SUBJECT: **TND-C-1-06 Final Development Plan Major Change & Preliminary Plat of 259 Lots for the Remaining Portion of Village at Magnolia Square Traditional Neighborhood Development**

SUBJECT: **TND-C-1-06 Final Development Plan, Development Review Committee (DRC)
Comments – Applicant Response**

SUBJECT: TND-C-1-06 Final Development Plan, TND VMS Additional Comments – Applicant Response

SHEET NUMBER
4
 DATE
 10/07/2021

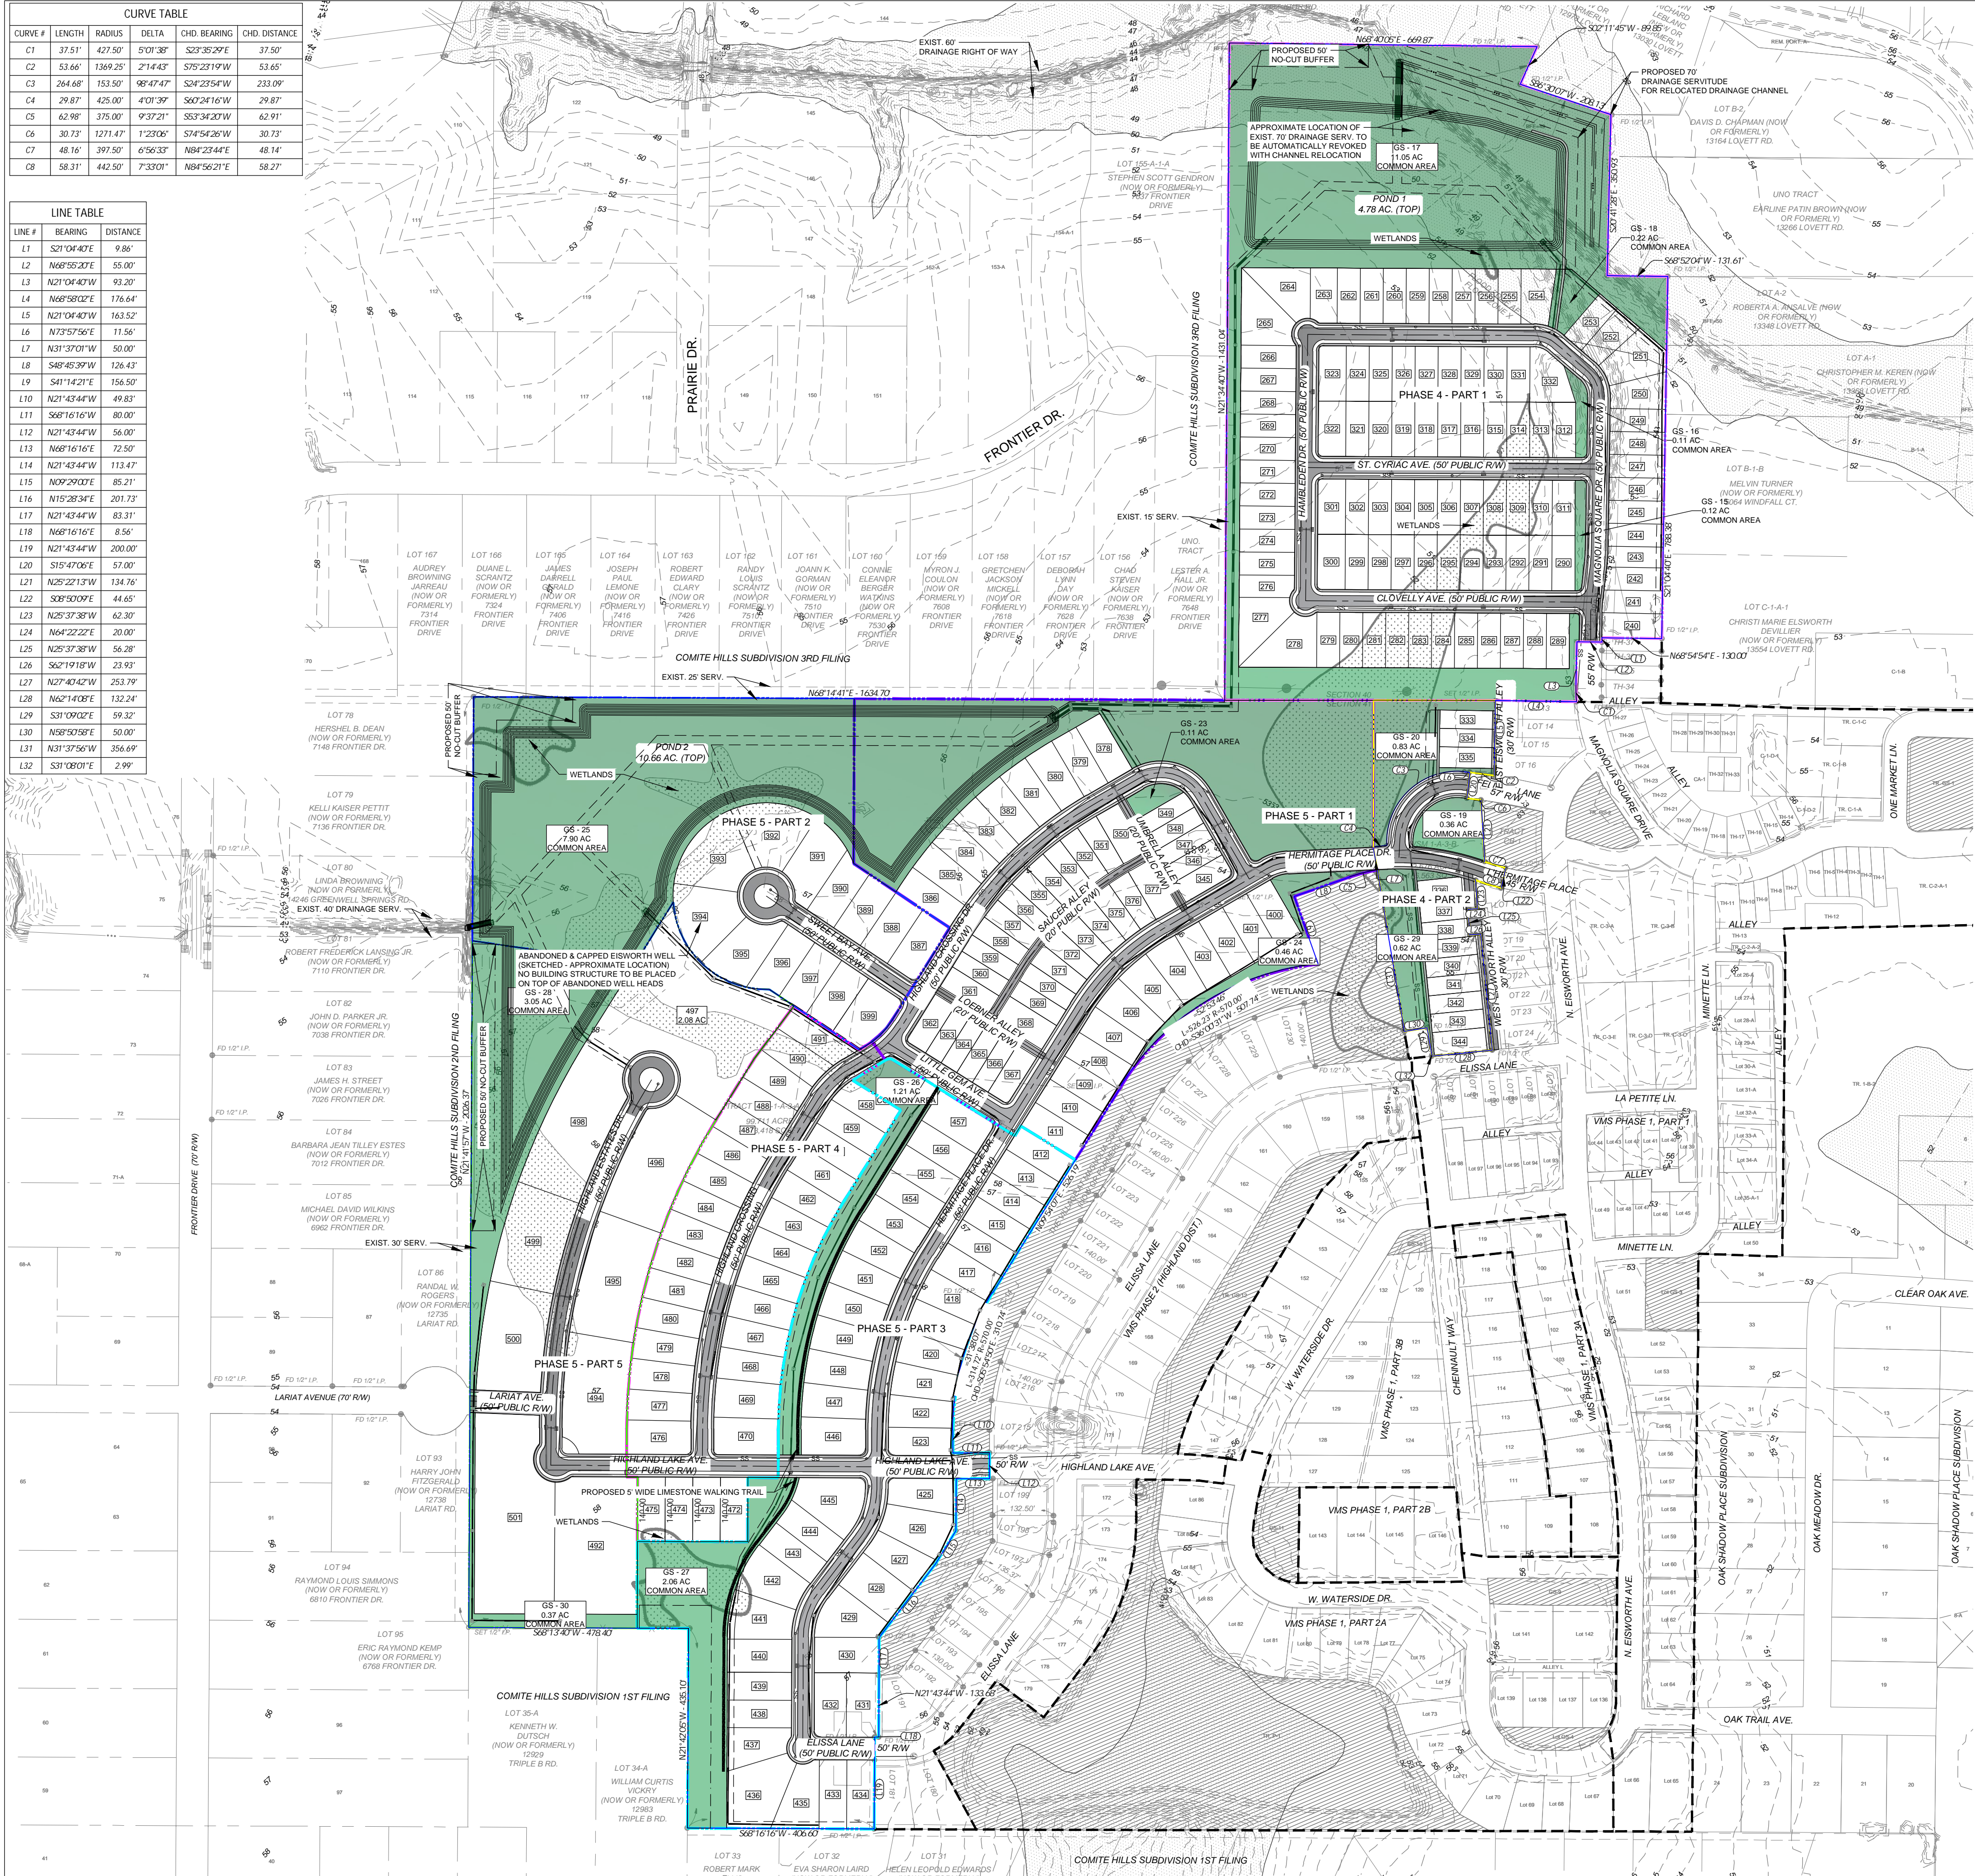
17. Provide a Bulk Regulation Table for Each Phase including Average Lot Width, Average Area and All Setbacks to further evaluate the Net Density Calculator in accordance with Section 14.8 D.4. a.i of the Zoning Code. Noted. See table with requested information below. Setbacks are noted on the Preliminary Plat RE: Sheet 4 Note 21.

SHEET NUMBER
5
DATE
10/07/2021

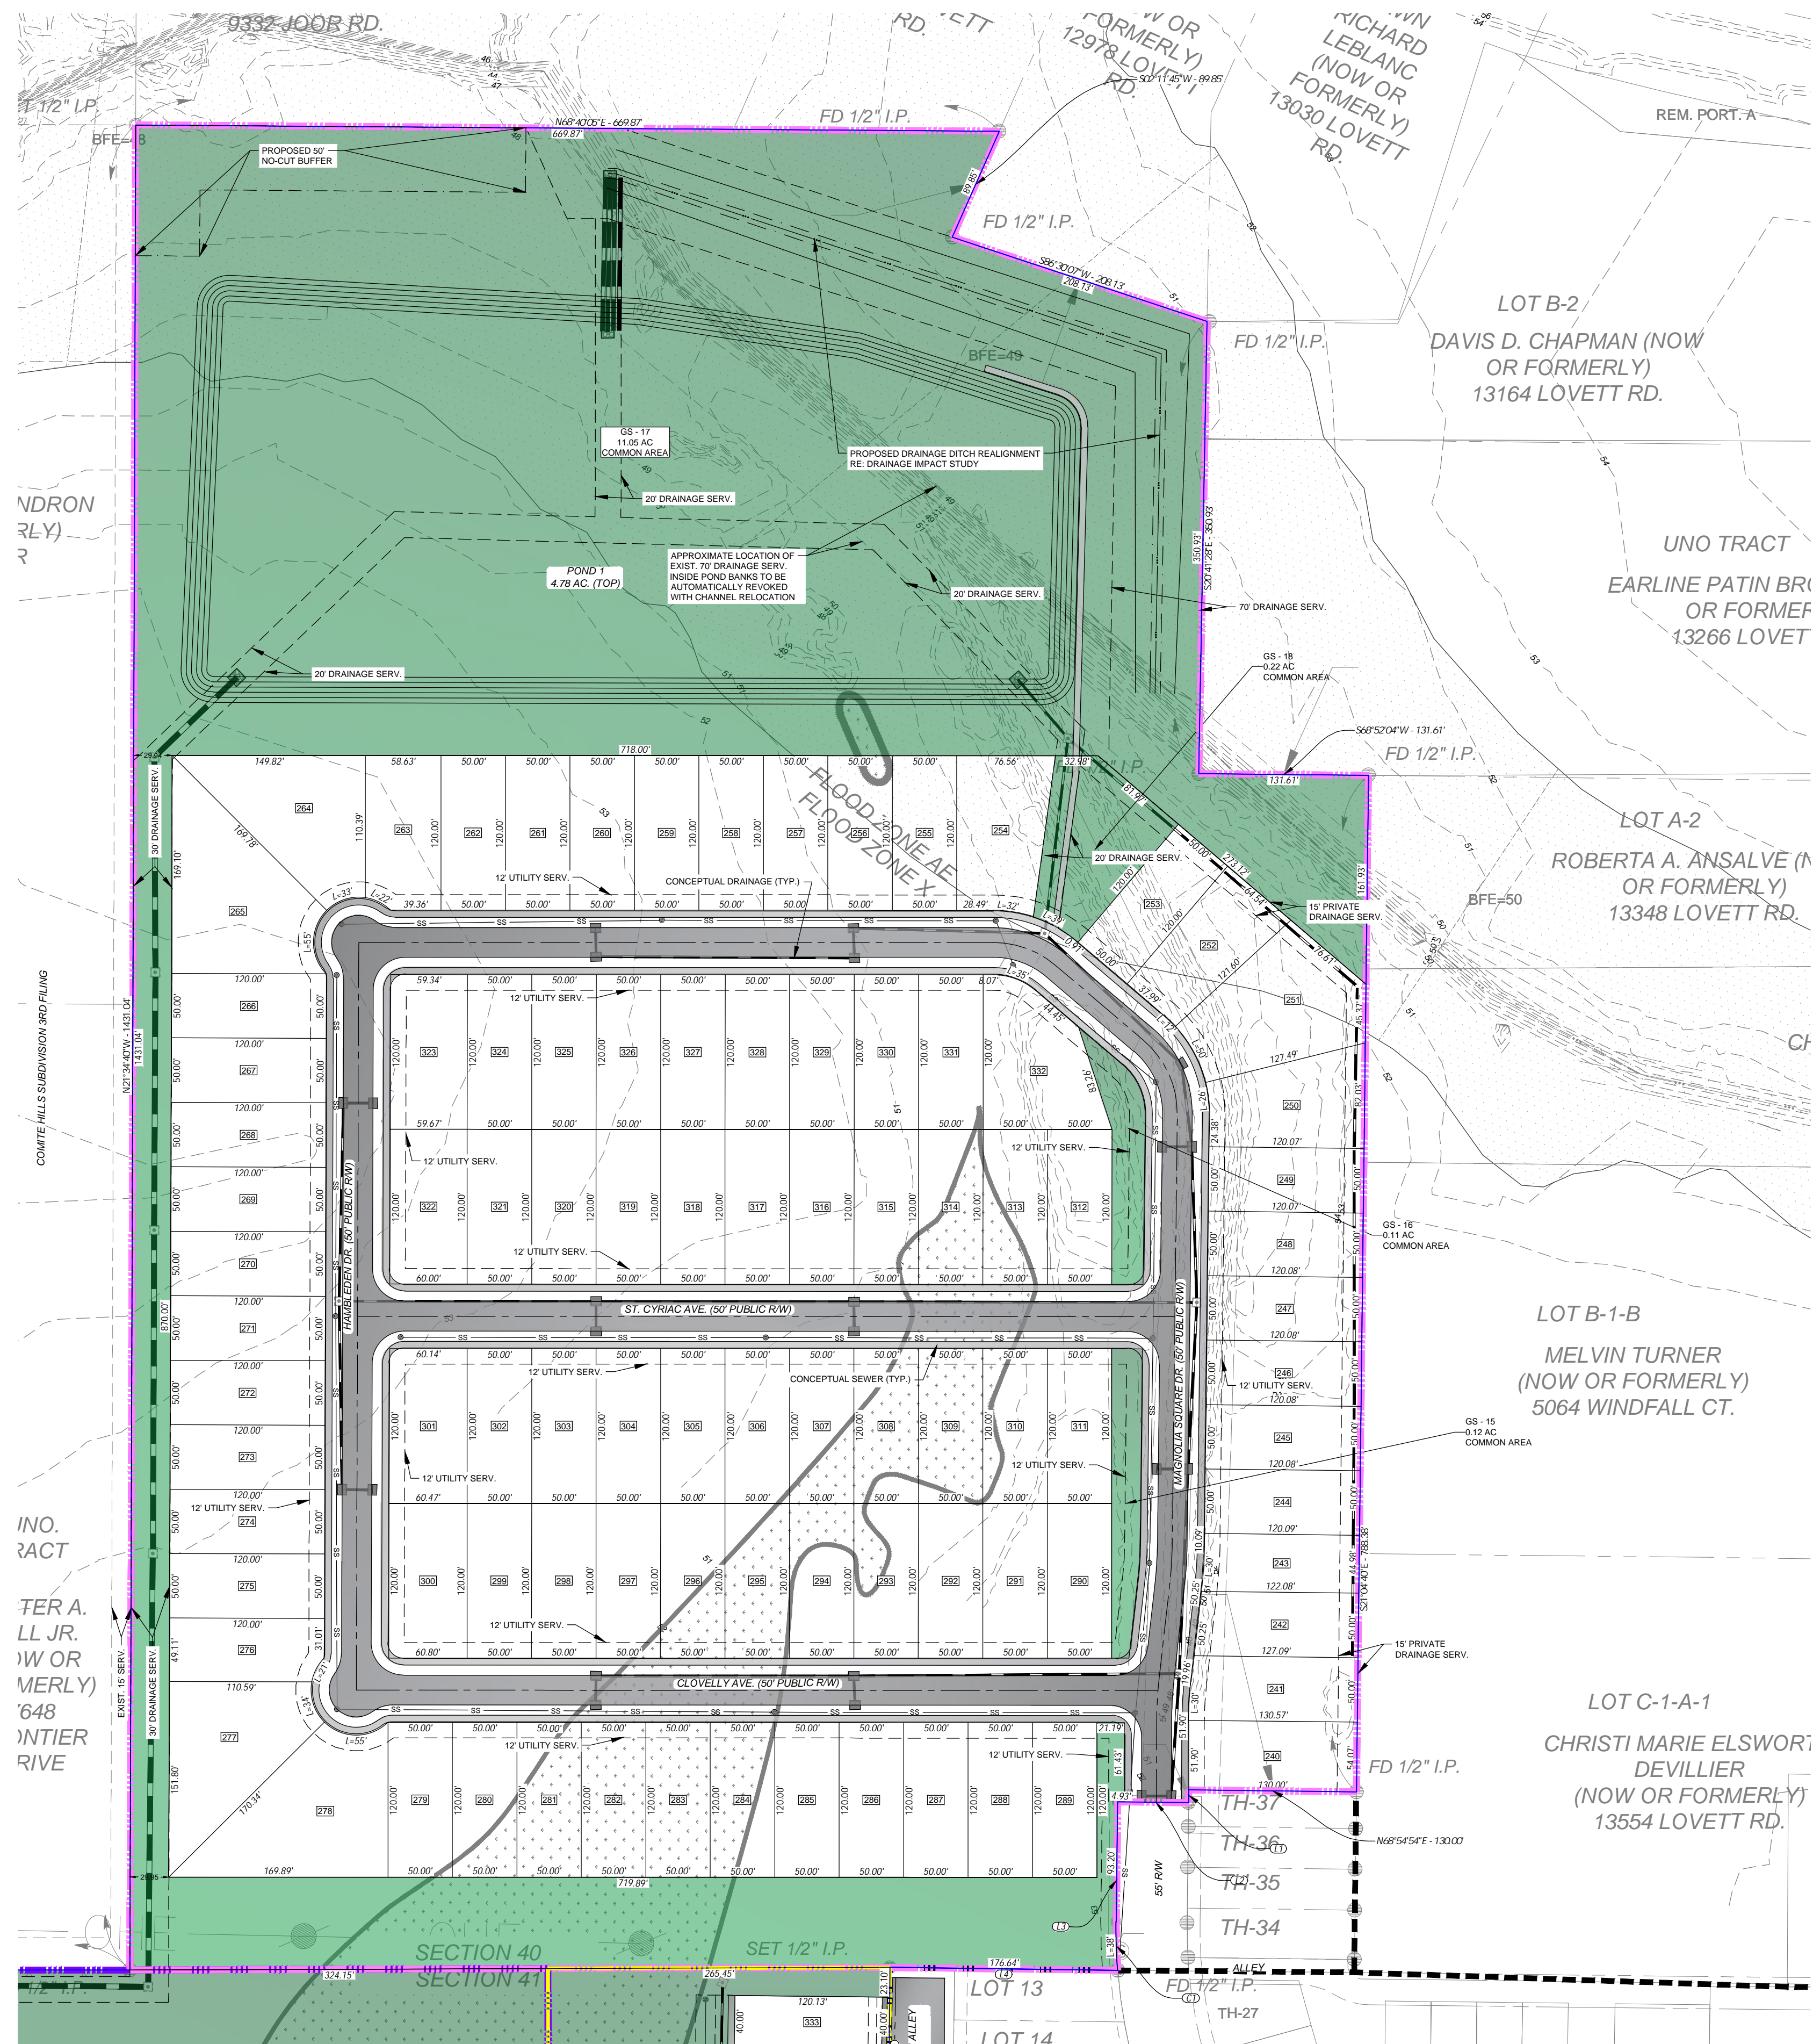
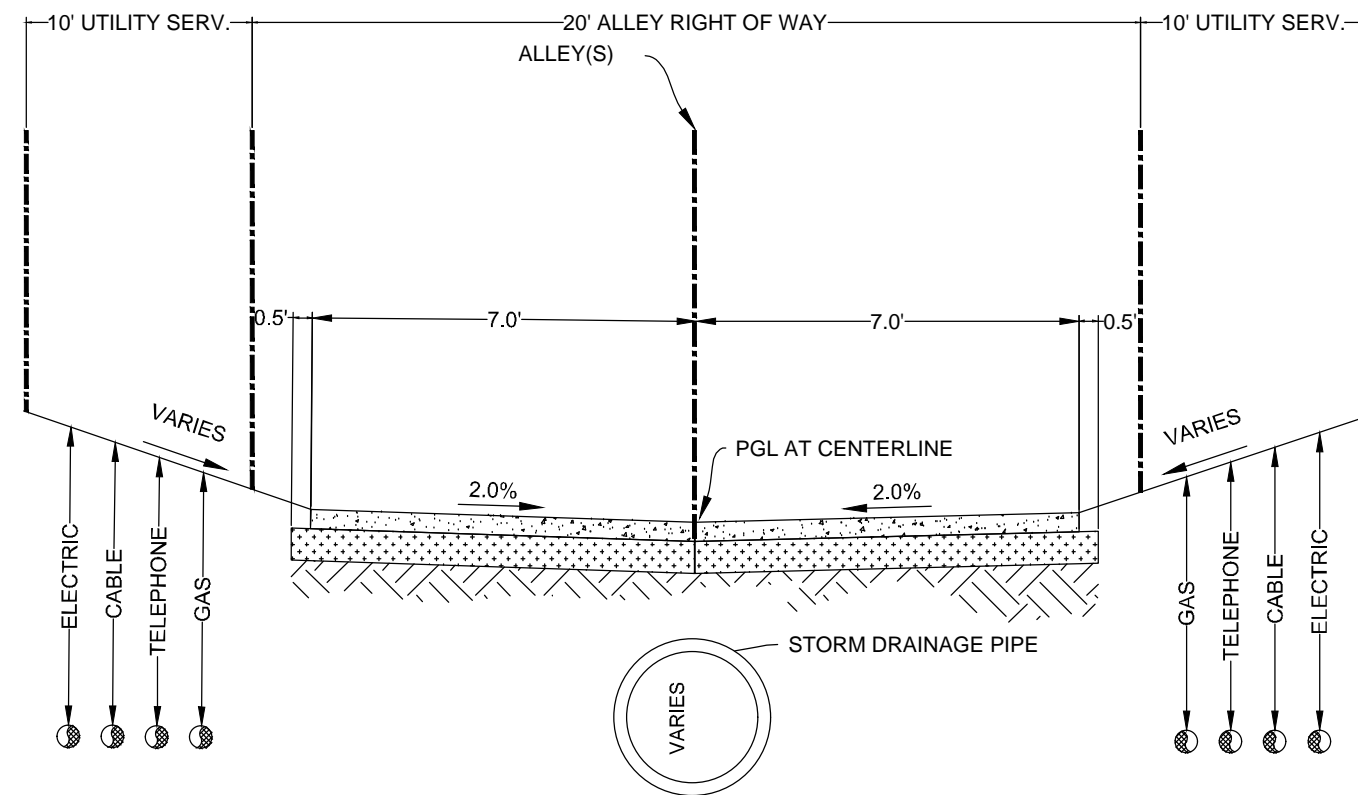
11. Street Section does not include a tree planting zone. There shall be a minimum average of one street tree on both sides of the street per 40 feet of frontage. (TND Ordinance) Alternatively Lots with more than 40 feet of street frontage measured at the building setback line within Major Subdivisions must have:(i)At least one Class A Tree or two Class B Trees (see Section 7:18.14 of the Development Code for definitions of these types of trees) must be planted on the lot between the front lot line and the front building set back line.(ii)Such tree or trees shall have at least a two-inch caliper measured six inches from the ground. (iii)The required tree or trees shall be planted prior to the occupancy of a house on the lot.(iv)Corner lots do not apply to this restriction. Tree planting is prohibited within the sight triangles of Appendix A.(v)Existing trees at the requested location that are not removed in connection with the construction may satisfy this requirement. A landscape plan showing including street trees and amenities is recommended. Noted. Revised Drawings are being submitted with this response letter reflecting the requested changes. RE: Landscape Plan by Reich Landscape Architects added to plans. Planting Zone in streets added to Typical Section on Sheet 5. Re: Revised Sheet 5.
